Final Drainage Report for
for

Windingwalk Filing 1

at
Meridian Ranch

December 2017

Scale	AS SHOWN	2 of 4	Date	DEC 2007
	Drawn by	LOA		Checked by
RATIONAL DRAINAGE MAP FINAL DRAINAGE REPORT WINDINGWALK FILING 1		TECH CONTRACTORS 12311 REX ROAD FALCON, CO 80831 TELEPHONE: 719.495.7444 FAX: 719.495.2457		
MERIDIAN RANCH		Revisions		
		No.	Date	Date
		-	-	-
		-	-	-
		-	-	-

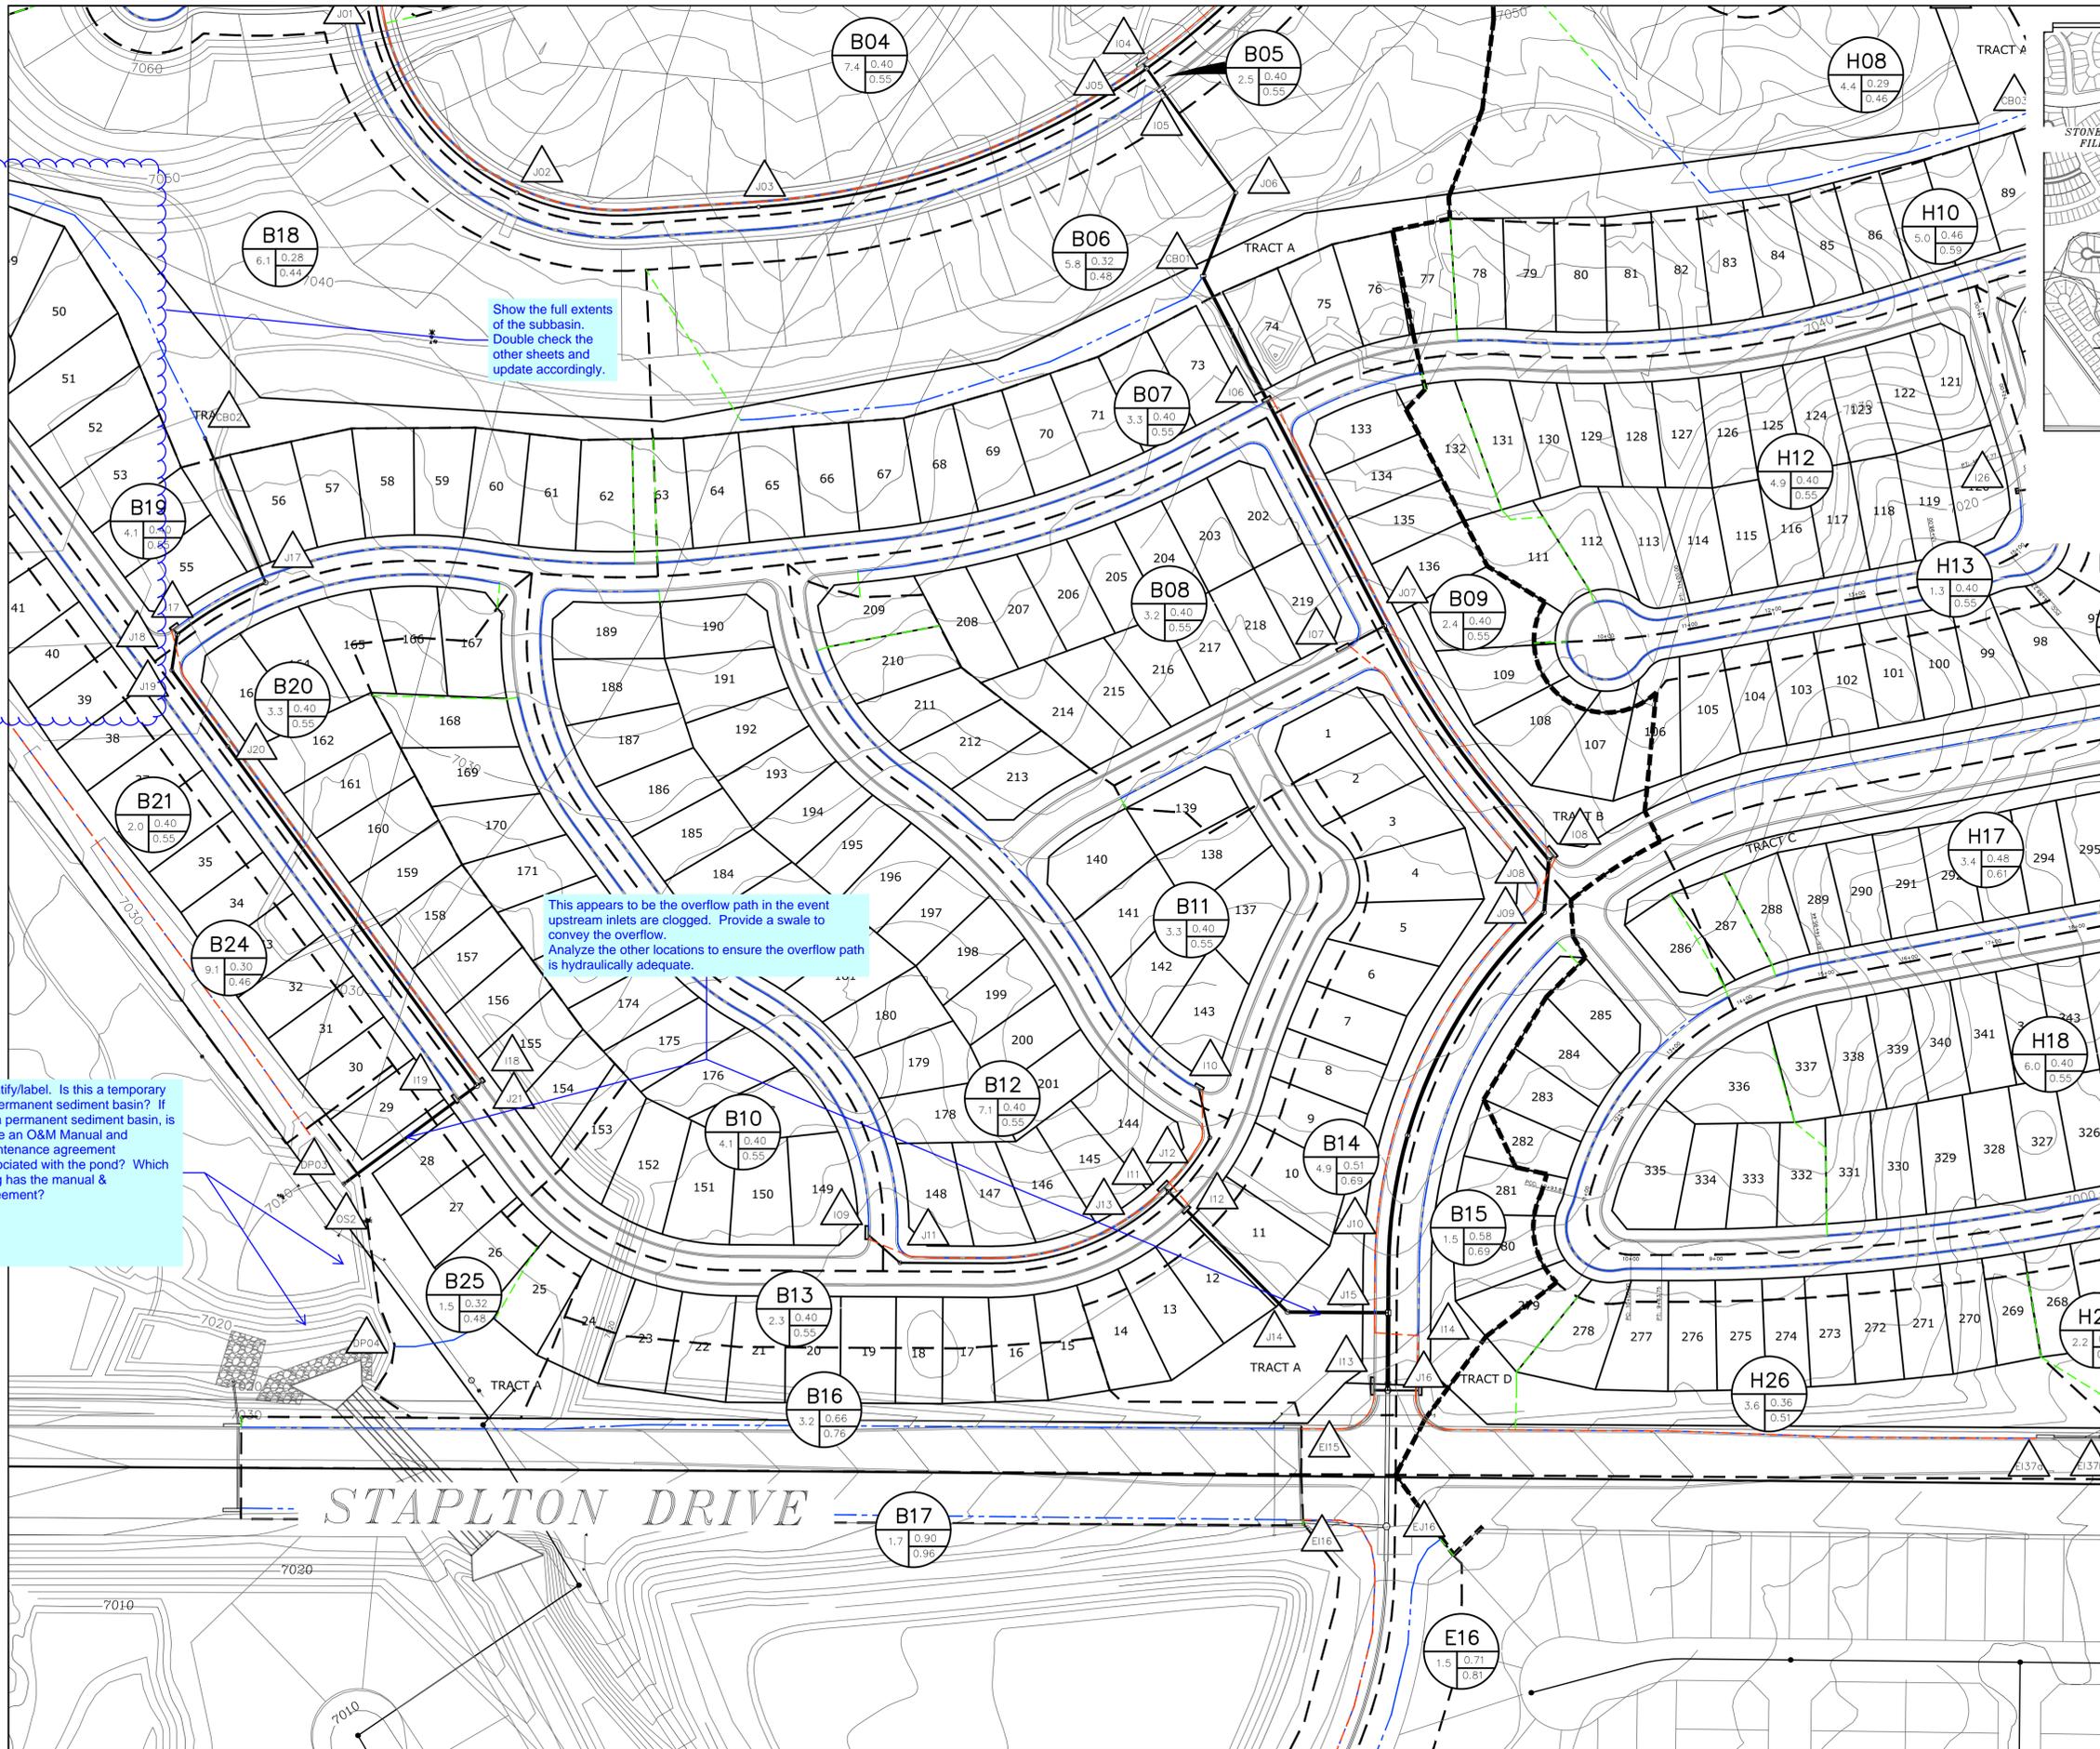
Show the full extents of the subbasin. Double check the other sheets and update accordingly.

This appears to be the overflow path in the event upstream inlets are clogged. Provide a swale to convey the overflow. Analyze the other locations to ensure the overflow path is hydraulically adequate.

Identify/label. Is this a temporary or permanent sediment basin? If it's a permanent sediment basin, is there an O&M Manual and Maintenance agreement associated with the pond? Which filing has the manual & agreement?

TECH CONTRACTORS 12311 REX ROAD FALCON, CO 80831 TELEPHONE: 719.495.7444 FAX: 719.495.2457	
MERIDIAN RANCH	
RATIONAL DRAINAGE MAP FINAL DRAINAGE REPORT WINDING WALK FILING 1	
Scale	AS SHOWN
Drawn by	LOA
Checked by	TAK
Date	DEC. 2007
3 of 4	
No.	
Revisions	
Date	
Init.	
Appr.	
Date

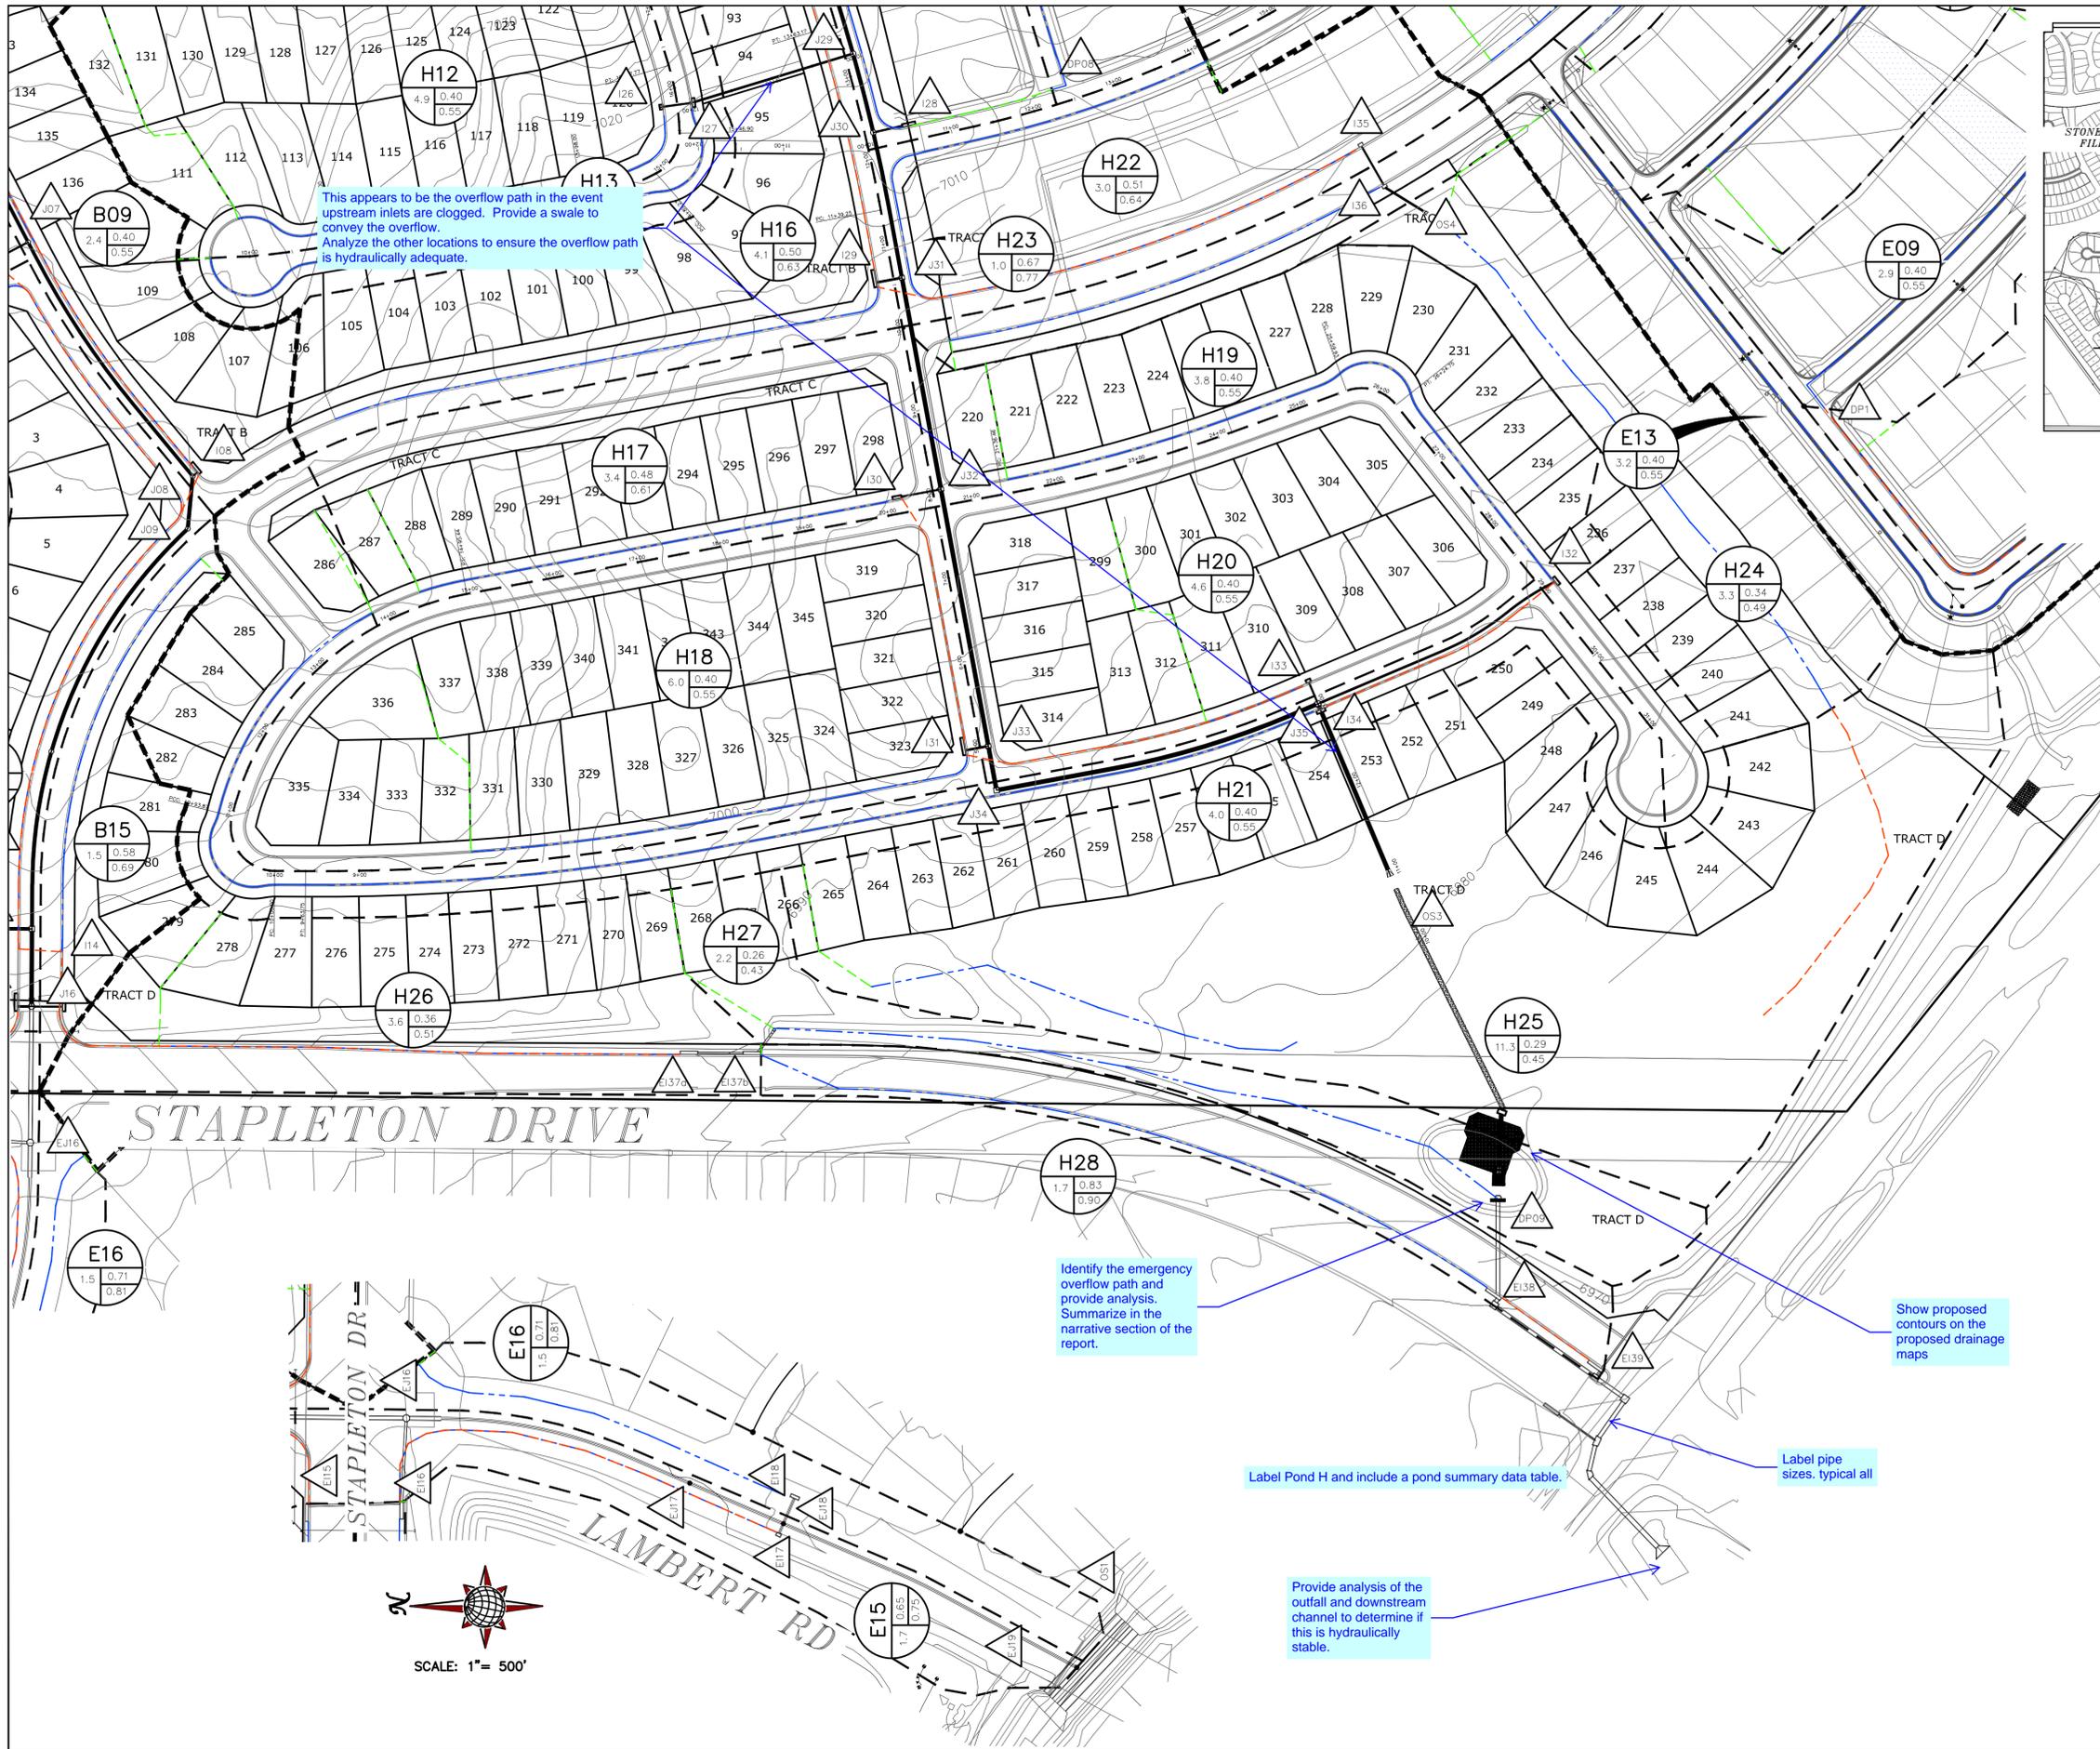
This appears to be the overflow path in the event upstream inlets are clogged. Provide a swale to convey the overflow. Analyze the other locations to ensure the overflow path is hydraulically adequate.

Identify the emergency overflow path and provide analysis. Summarize in the narrative section of the report.

Show proposed contours on the proposed drainage maps

Provide analysis of the outfall and downstream channel to determine if this is hydraulically stable.
